TOLEDO-LUCAS COUNTY PLAN COMMISSIONS

DATE: February 15, 2019

REF: SUP-10006-18

SUBJECT: Request for a Special Use Permit for Used Auto Sales at 1108 Holland-Sylvania Road.

REVISED ELEVATIONS

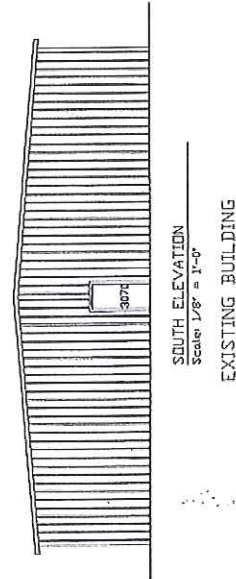
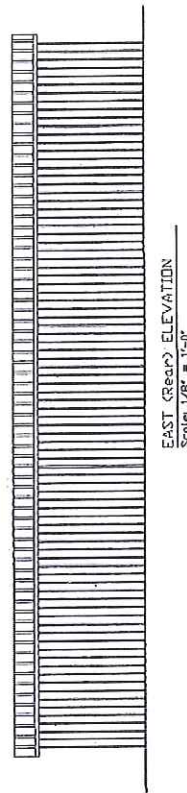
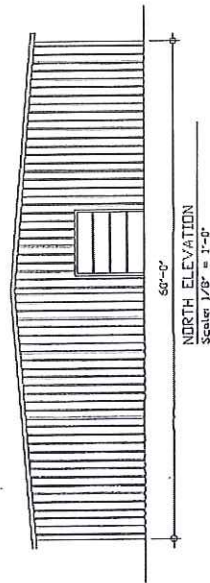
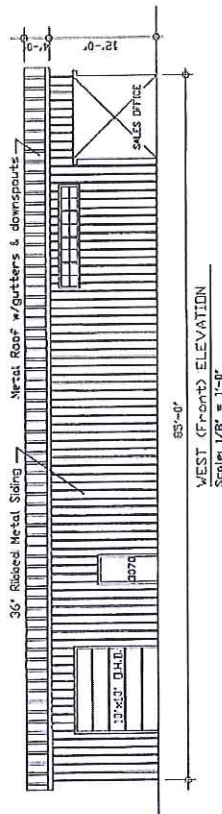
Pursuant to TMC§1109.0500 – *Building Façade Materials and Color*, predominate exterior building materials shall be high-quality materials. For facades visible from the public right-of-way, predominate materials must comprise at least seventy-five percent (75%) of the total wall area of the façade. Exterior building materials shall not include concrete blocks, concrete panels or wood sheet goods as a predominant material.

The site plan submitted depicts a building addition located on the front of the existing building. The revised building elevations submitted depict the building façade material as stucco which conforms with the Design Standards of TMC§1109.0500.

33. The building design shall meet the requirements of TMC§1109.0500 *Building Façade Materials and Color*. For facades visible from the public right-of-way, predominant materials must comprise at least seventy-five percent (75%) of the total wall area of the façade. Exterior building materials shall not include concrete blocks, concrete panels or wood sheet goods as a predominant material. **Acceptable as depicted (stucco) on revised elevations received 2/1/2019.**
